City of Hailey

Agenda
HAILEY PLANNING & ZONING COMMISSION
Monday, May 18, 2020
Virtual Meeting
5:30 p.m.

STAFF REPORT
Hailey Planning and Zoning Commission
Regular Meeting of May 18, 2020

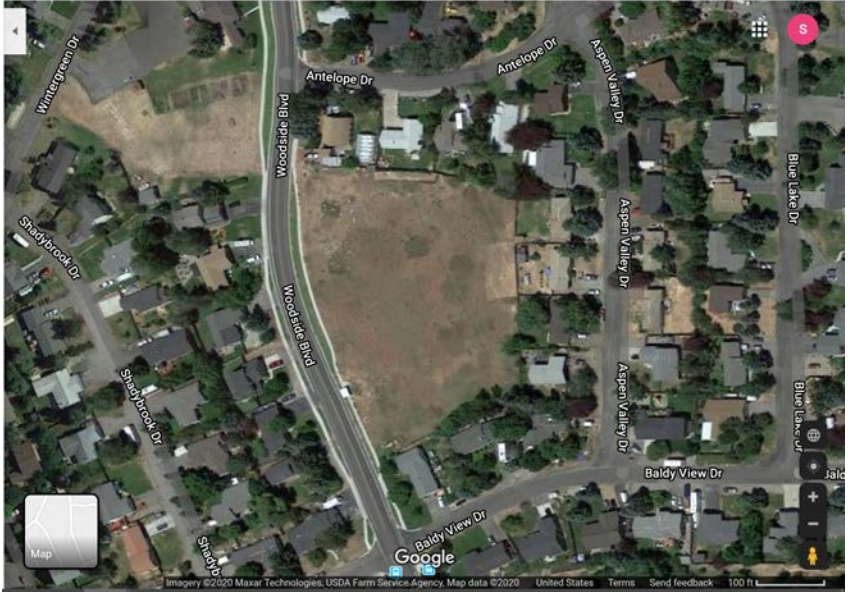
Staff Comments	<i>Snow storage areas are shown in grass landscape areas.</i>

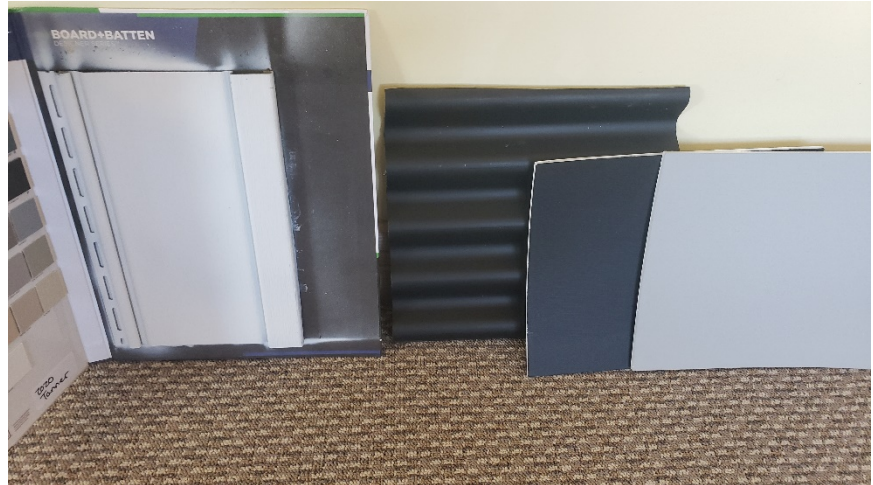
The Commission also expressed concern that the color scheme was too stark. The Applicant provided a revised rendering to show a less stark color scheme with grey added to the popouts.
